Title - Sujet Beef Feedlot Water Renovation	
Solicitation No. - N° de l'invitation EP922-180336/B	Amendment No. - N° modif. 003
Client Reference No. - N° de référence du client EP922-180336	Date 2017-08-10
GETS Reference No. - N° de référence de SEAG PW-\$PWU-066-11146	
File No. - N° de dossier PWU-7-40041 (066)	CCC No./N° CCC - FMS No./N° VME
Solicitation Closes - L'invitation prend fin at - à 02:00 PM on - le 2017-08-18	Time Zone Fuseau horaire Mountain Daylight Saving Time MDT
F.O.B. - F.A.B. Plant-Usine: <input type="checkbox"/> Destination: <input type="checkbox"/> Other-Autre: <input type="checkbox"/>	
Address Enquiries to: - Adresser toutes questions à: Lee, Mony	Buyer Id - Id de l'acheteur pwu066
Telephone No. - N° de téléphone (780) 224-6675 ()	FAX No. - N° de FAX (780) 497-3510
Destination - of Goods, Services, and Construction: Destination - des biens, services et construction:

SOLICITATION AMENDMENT No. 003

Diagram D10
Installation configurations — Direct buried

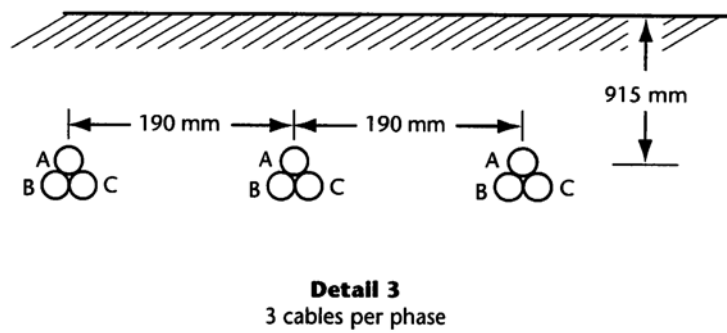
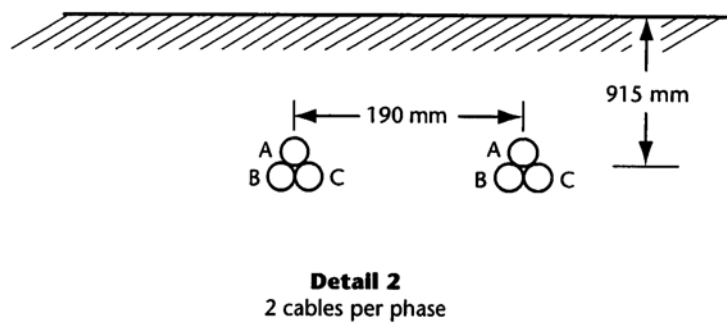
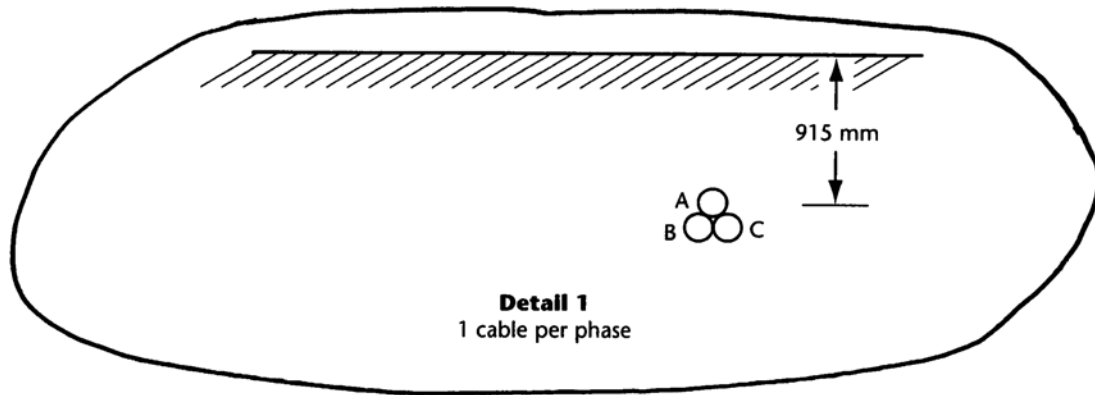
Question 3. On the feeder schedule on drawing E201, #1 refers to (Table D108, Diagram D10, Detail 1). Where do I find these tables and diagrams?

Response: Please refer to CEC 2015, page 557 (Attached)
